Board of Adjustment **Notification Plan for** **Case No A-19-10300050**

Design #	
0610405AR3	
Sheet	3 of 3
Location	
#363	
Address	
4635 RITTIMAN RD SAN ANTONIO, TX	
Acct. Rep.	DEBBIE MOLTZ
Coordinator	STEPHANIE MOORE
Designer	IH
Date	6/11/15
Approval / Date	
Client	
Sales	
Estimating	
Art	
Landlord	
Engineering

BOA-19-10300050
Subject Property – 4635 Rittiman Road

REPAIR 95 FT PYLON

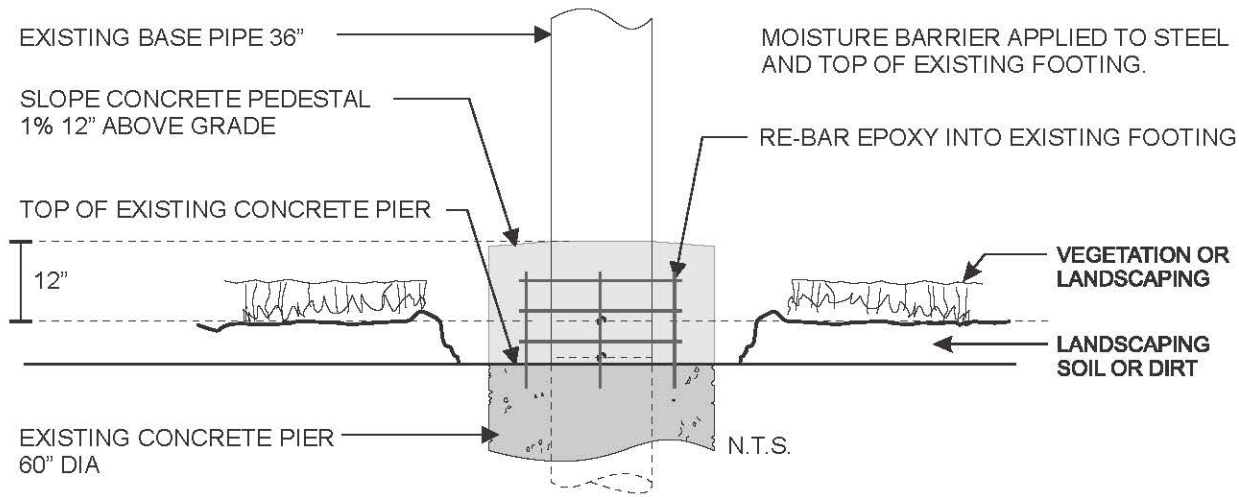
REDUCE OVER ALL HEIGHT

REDUCE O.A.H.
KEEP PORTION OF 20" STEEL TO SLEEVE INTO 30" WITH NEW STOP PLATE AND 2 NEW RING PLATES.

- 1 - ADD CONCRETE PEDESTAL WITH RE-BARS AND EXTEND TO 12 INCH ABOVE GRADE. DOWEL RE-BARS INTO EXISTING FOOTING WITH EPOXY. COMPLETELY REMOVE RUST AND EXISTING PAINT FROM STEEL, PRIME AND PAINT PRIOR TO ADDING CONCRETE.

- 2 2ND AND 3RD TRANSITIONS FROM GRADE: ADD STEEL GUSSETS AS SHOWN ON DRAWING TO REINFORCE CAP PLATE (EXTENSION DEFICIENCY)
- 3 ALL TRANSITIONS: CHECK ALL RING PLATES FOR PLUG WELDS AND ADD IF MISSING. ADD MINIMUM FOUR (4) ONE (1) INCH LONG WELDS @ EACH PLATE. ALSO COMPLETELY FILL EXISTING HOLES AT RING PLATES WITH WELD MATERIAL.
- 4 ALL TRANSITIONS: ADD ADDITIONAL WELD PASS BETWEEN CAP PLATE AND BOTTOM STEEL SUPPORT.
- 5 SCRAPE / GRIND REMOVE OLD EXCESS PAINT AND RUST ON MAIN SUPPORT PIPE AT ALL TRANSITIONS FROM 1 FOOT ABOVE CAP PLATE TO 1 FOOT BELOW LOWEST RING PLATE. PRIME AND RE-PAINT.
